Re: Sunrise Project Modification 7 – Request for Information (EPA Advice on Submissions Report)

Response to Air Quality-related Matters in the EPA Advice on the Submissions Report

Sunrise Project - Project Execution Plan Modification - Response to Noise-related Matters in the EPA Advice on the Submissions Report

Modified Mine and Processing Facility
Conceptual General Arrangement
Operational Year 1

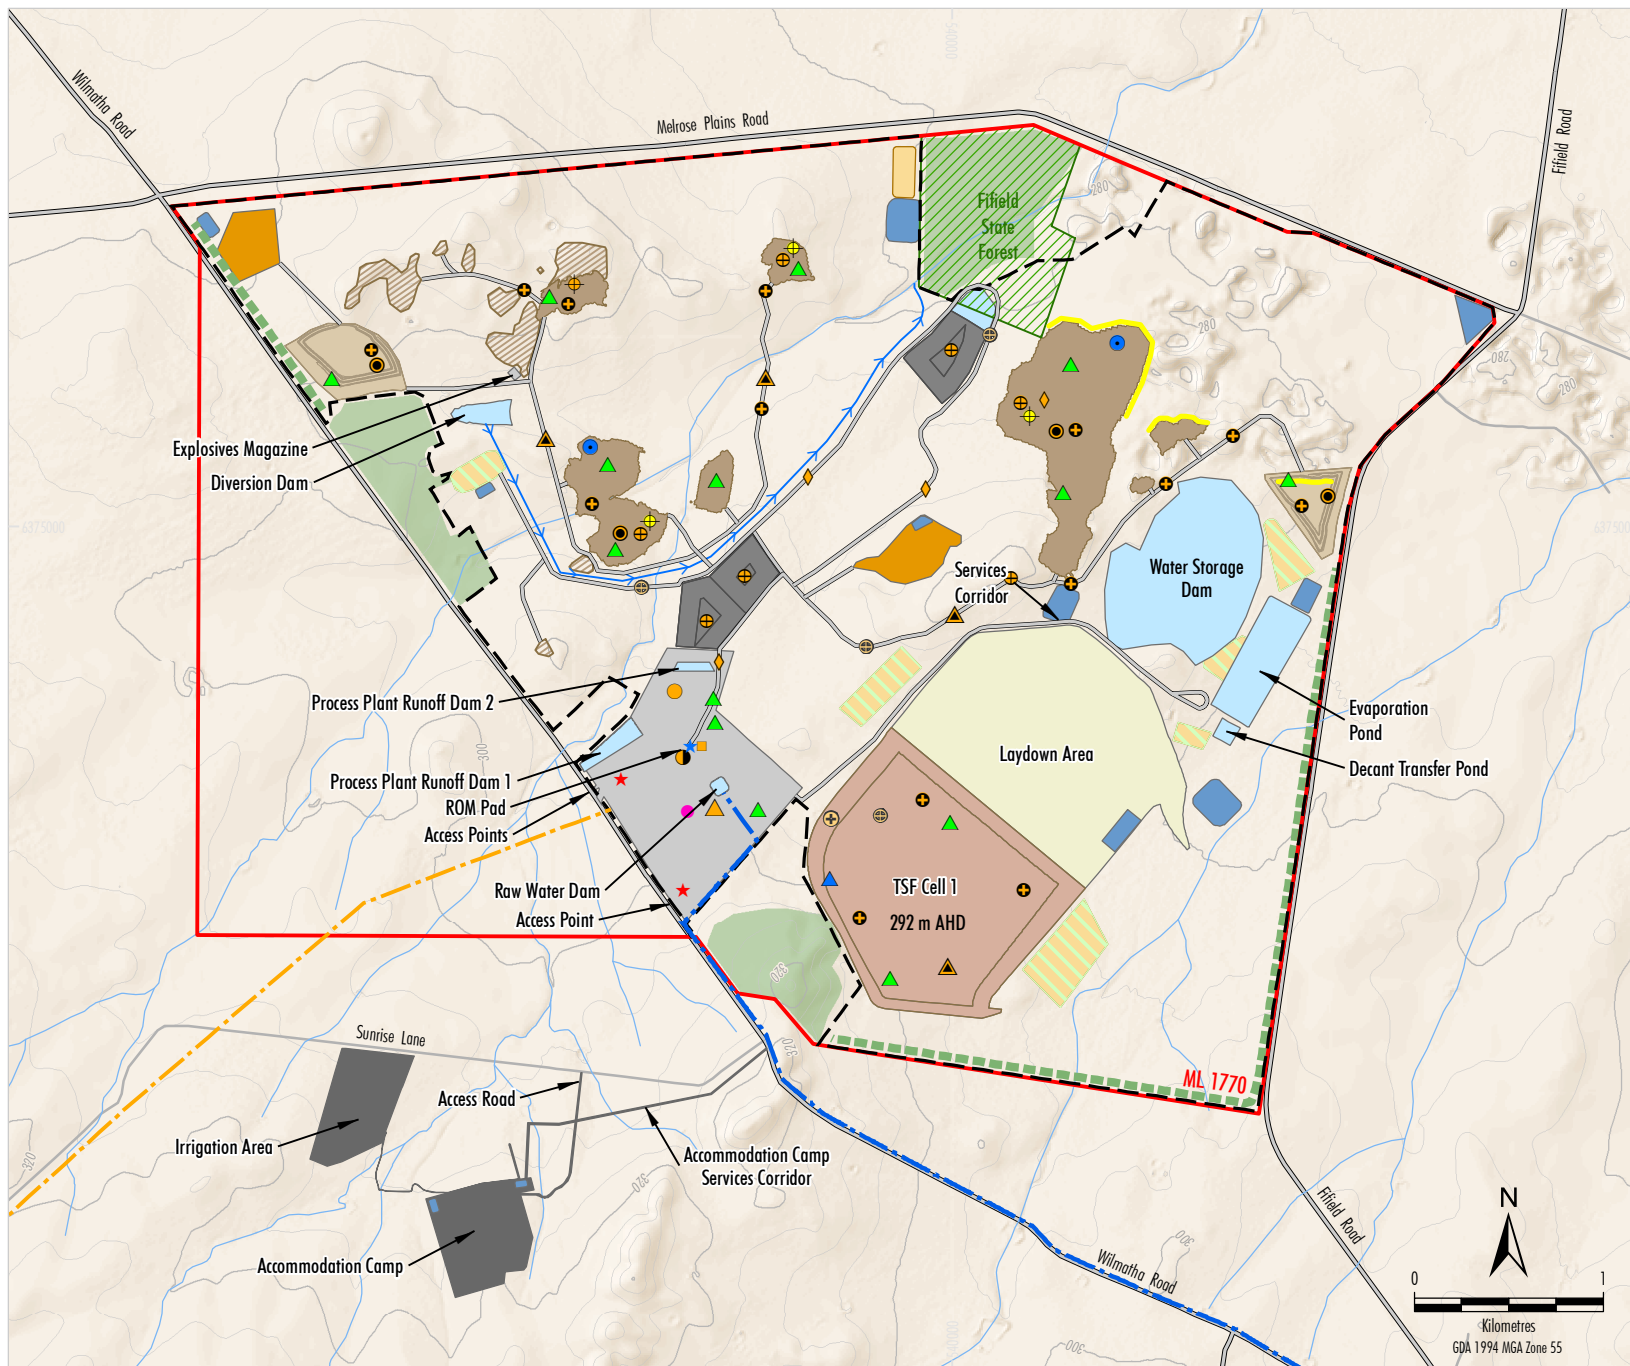
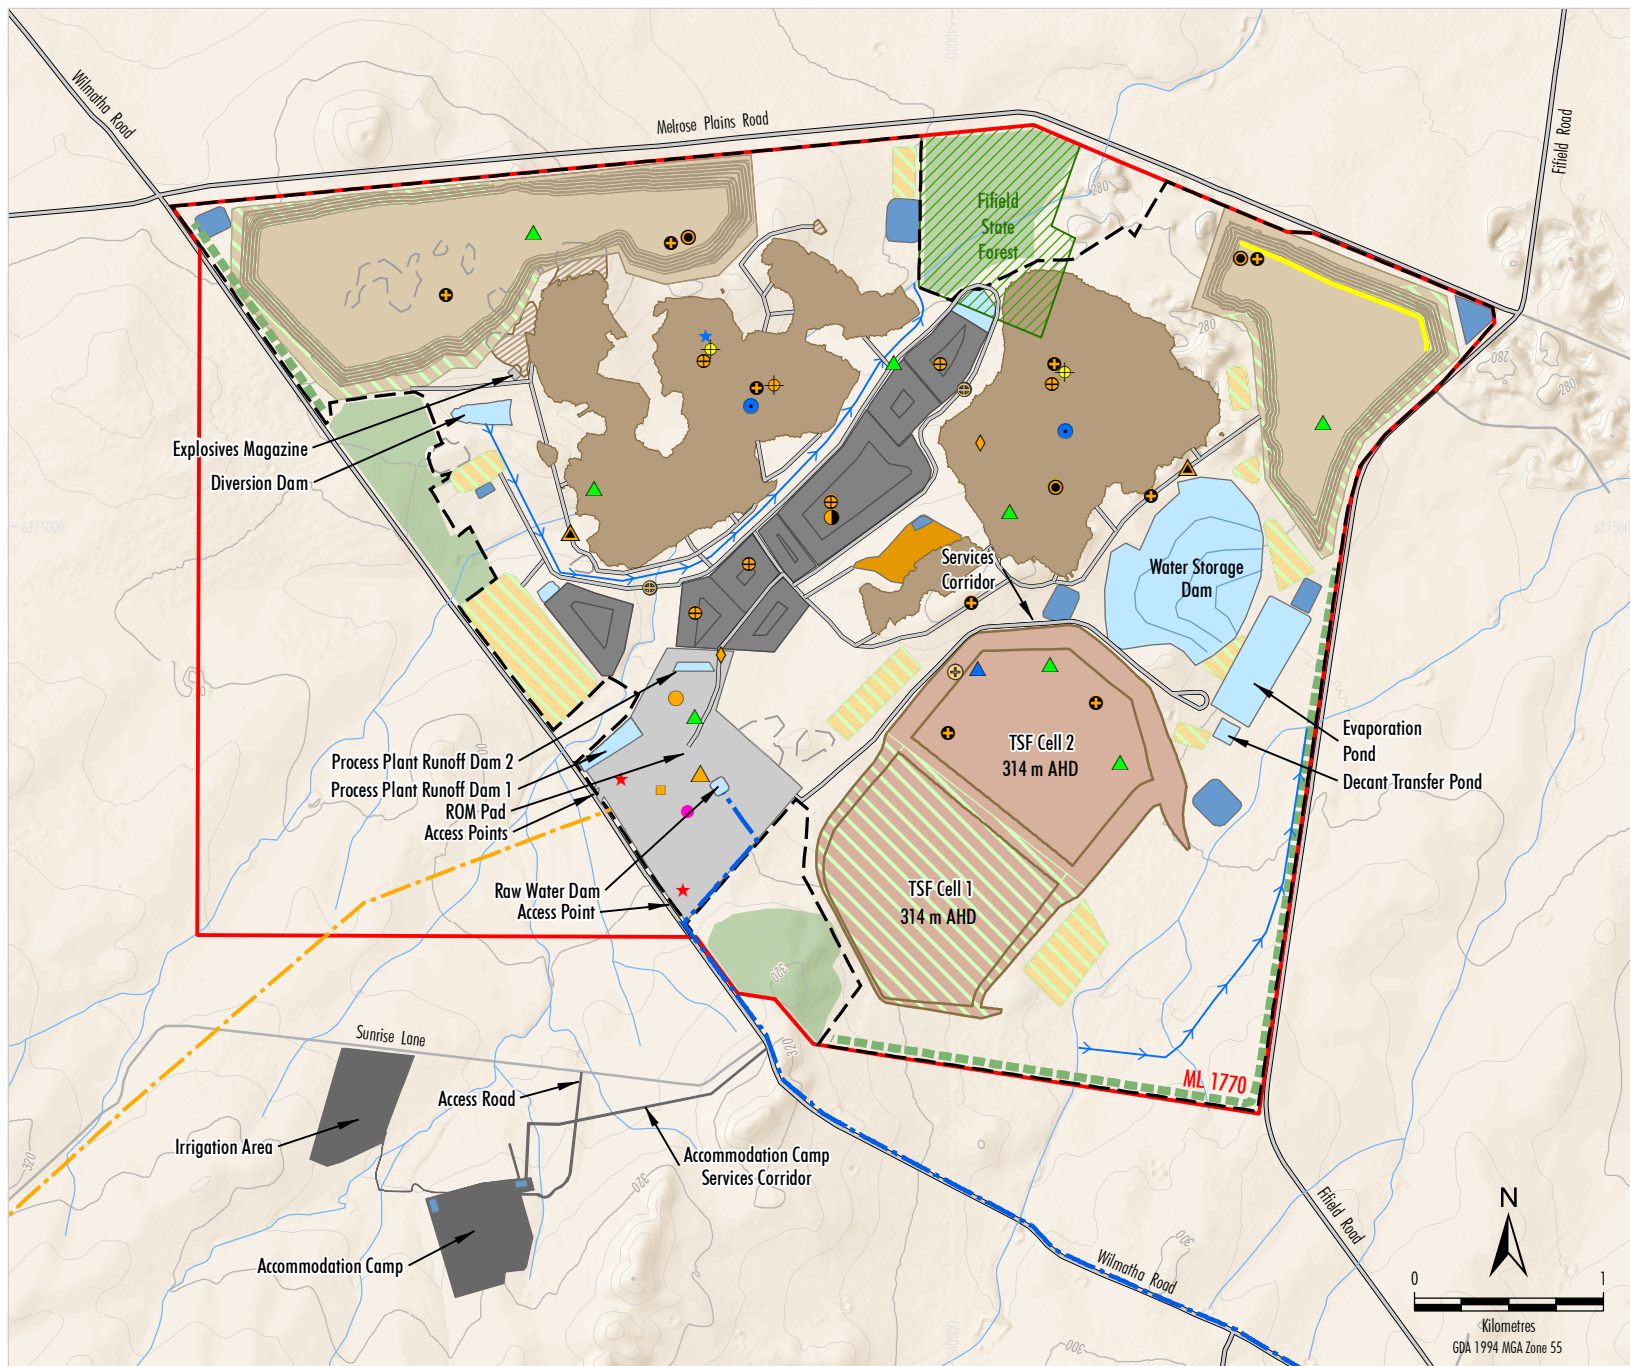
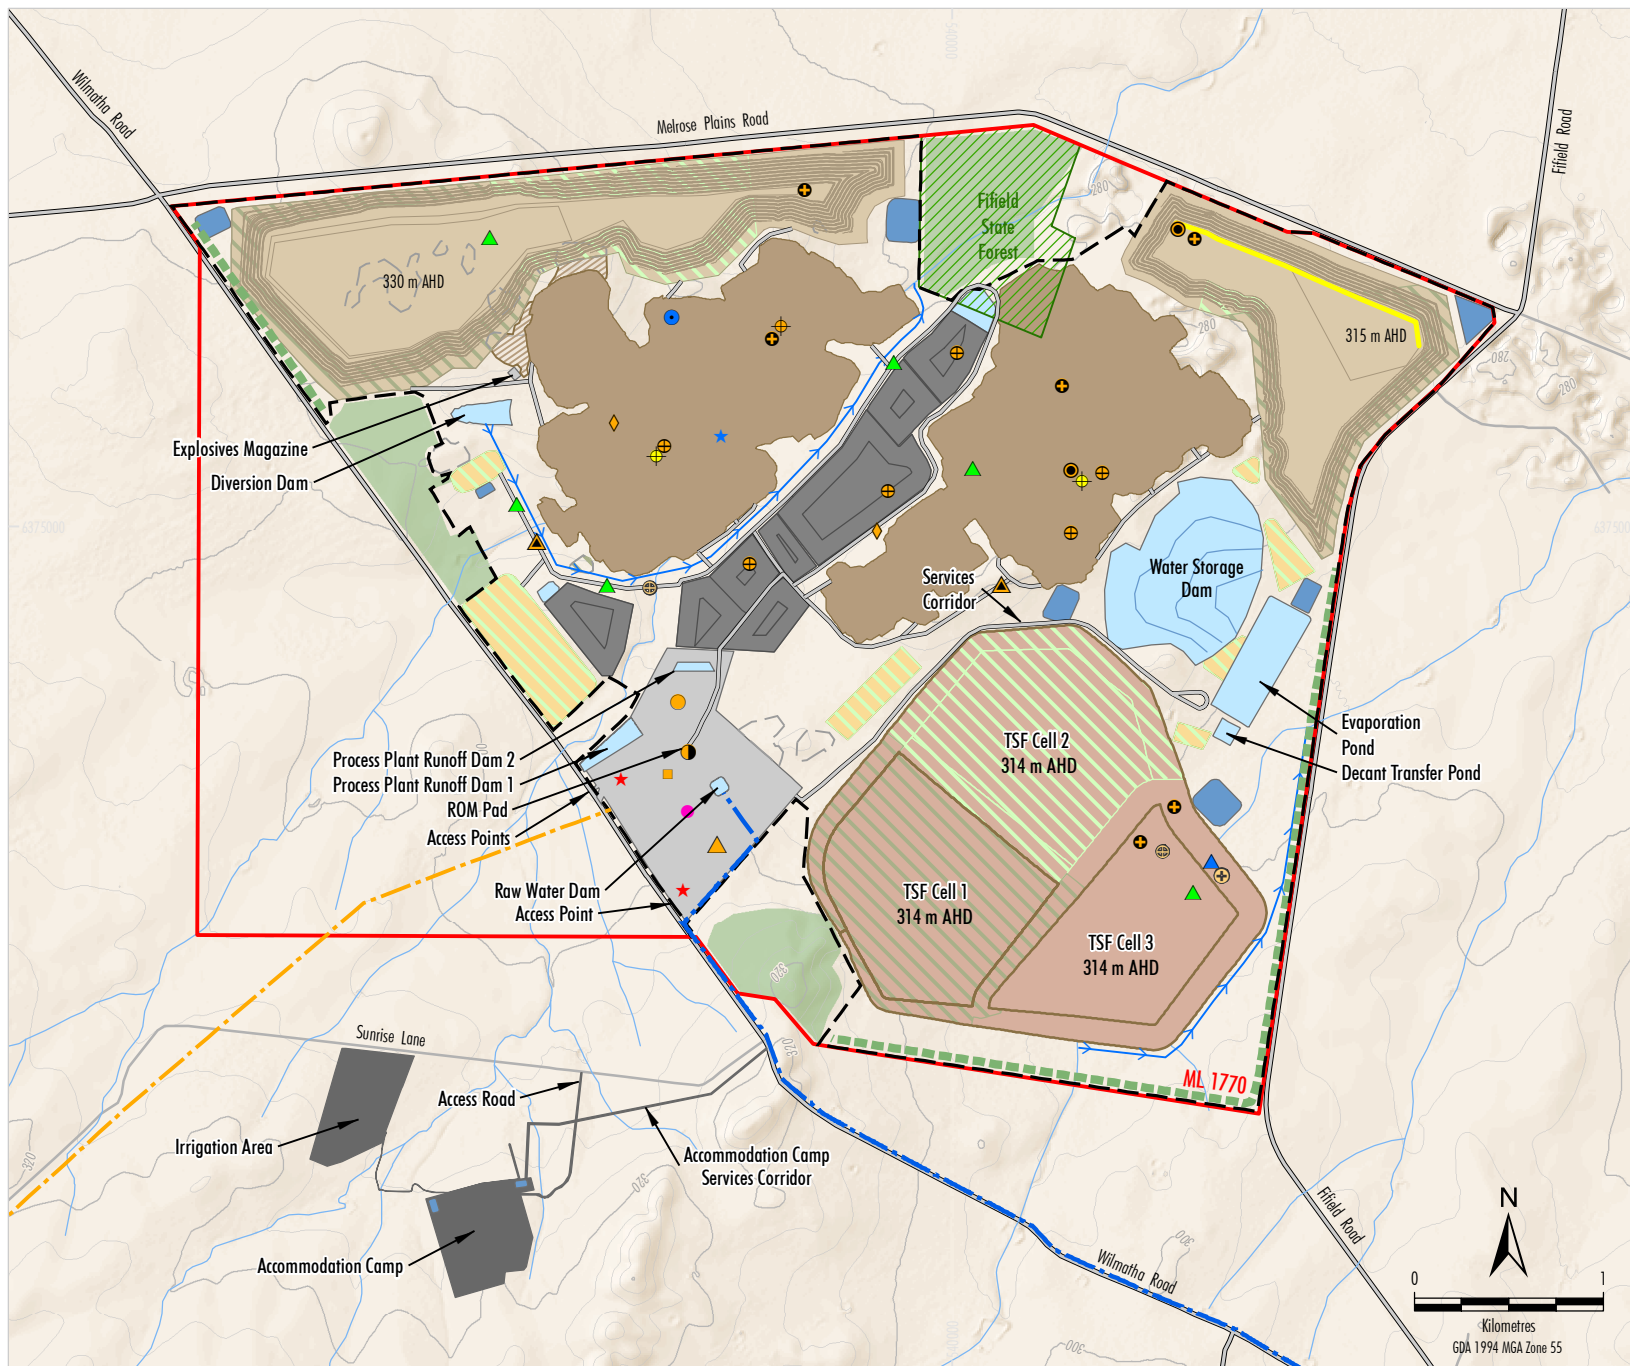
Sunrise Energy have identified that a noise bund to shield Currajong Park from potential noise emissions from the premises is not considered necessary. Sunrise Energy allege that the noise sources would be located too far away from the bund to create a significant reduction in noise. Sunrise Energy also consider that a noise bund would result in limited noise mitigation when inversion conditions are present at the premises.

The EPA notes that no quantitative evidence has been provided to support these conclusions. The EPA does not consider inversion conditions to be adequate justification as they typically occur during night time and only for a limited part of the year. Furthermore, the response discounts the potential benefits a noise bund would provide when inversions are not present, which is likely to be most of the time operations occur.

In that regard, the EPA does not consider that appropriate justification has been provided for not constructing a noise bund. The EPA reiterates that a noise bund may be a reasonable and feasible noise mitigation measure for the project.

- Year 1 – 10 m high acoustic bunds located on the north and eastern sides of the eastern open cut pits and the northern side of the north-eastern waste rock emplacement (Figure 1).
- Year 10 – 10 m high acoustic bunds located on the northern side of the north-eastern waste rock emplacement (Figure 2).
- Year 17 – 10 m high acoustic bunds located on the northern side of the north-eastern waste rock emplacement (Figure 3).

Acoustic bunds were modelled at 10 m height for all scenarios. The predicted noise levels at Currajong Park 1 and 2 for the three operational noise modelling scenarios and the relevant assessable meteorological conditions are summarised in Table 1.

The noise modelling shows that the acoustic bunds could possibly reduce predicted noise levels at Currajong Park 1 and 2 by up to 1 dB under certain meteorological conditions (although there would be no reduction for the majority of scenarios and meteorological conditions considered) as shown in Table 1. The noise modelling did however show that the acoustic bunds would reduce the predicted noise level associated with certain individual fleet items that are practicably able to work close to the acoustic bunds, however, the overall noise levels at Currajong Park 1 and 2 would still only reduce by up to 1 dB. This shows that although the acoustic bunds may be effective at reducing noise for some individual fleet items that are able to work close to the acoustic bunds, the acoustic bunds do not result in an appreciable reduction in overall noise levels from the mine and processing facility at Currajong Park 1 and 2 (as it is not practicable for all fleet items to work near the acoustic bunds).

A review of the effectiveness of the acoustic bunds to reduce potential noise emissions at Currajong Park 1 and 2 to below the relevant Development Consent (374-11-00) criteria (i.e. 37 dB[A] in the day, evening and night-time periods) has been undertaken. In particular, the use of acoustic bunds to maximise shielding of key noise generating fleet items, most notably in the early years of operation of the eastern open cut pits (Figure 1) and for the north-eastern waste rock emplacement (Figures 1 to 3) was considered and it was concluded:
